Request:
Site Plan Application

Applicant:
Nate Bailey, Peninsula Architects

The approximate one (1) acre project area contains three (3) existing buildings on six (6) separate parcels. The applicant is proposing to redevelop the property into a cultural campus, designated as Park Lane Square. Proposed improvements include:

Hudson Planning Commission	SITE PLAN REVIEW
Case No. 2021-1046	October 11, 2021

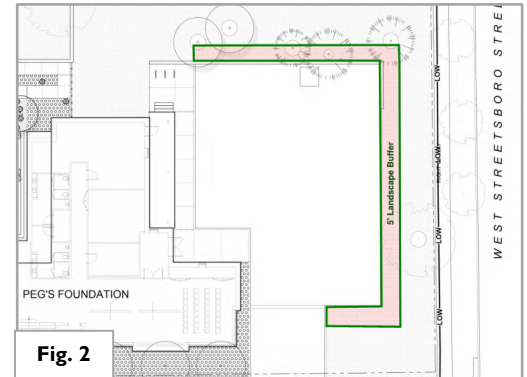
Staff notes the proposed Peg's Foundation building would not be built to edge of the sidewalk or property line; however, the majority of the frontage is near the sidewalk/right-of-way and hardscaped up to the front of the building. Staff recommends the proposed twelve (12) foot sidewalk with street tree planting be extended along the entire length of the building façade and the space between the public sidewalk and the building be updated to a pedestrian amenity zone (hardscape, seating) to meet the intent of the requirement as depicted in Figure 1.

❑ **Building Siting and Orientation** The Land Development Code requires commercial/retail buildings to maintain a continuous wall plane at the front property line and for the main entrance to a principal structure to face the street. Staff notes the front entrance of the Peg's Foundation building needs a revised to incorporate an entryway along First Street to meet this requirement.

1. A lot consolidation shall be recorded prior to the issuance of a zoning certificate.
2. The proposed twelve (12) foot sidewalk with street tree plantings shall be extended along the entire length of the western building façade and the space between the public sidewalk and the building be updated to a pedestrian amenity zone (hardscape, seating).

3. The west elevation and floorplan shall be revised to include a main entrance along First Street.
4. Perimeter landscaping shall be applied to the proposed parking lot in accordance with Section 1207.04(l)(3) "Perimeter Landscaping for Parking Lots".

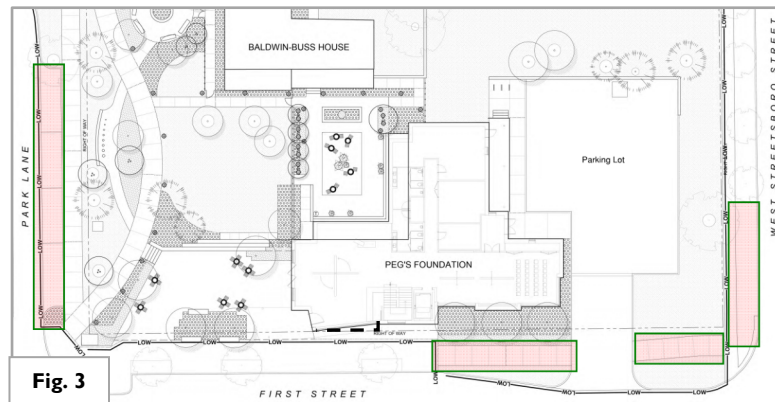
The LDC requires a minimum five (5) foot landscape buffer for the parking areas. The buffer shall provide an opaque screen of a height of at least three (3) feet. Staff notes the proposed parking lot would require additional landscaping to meet this requirement (see Figure 2).
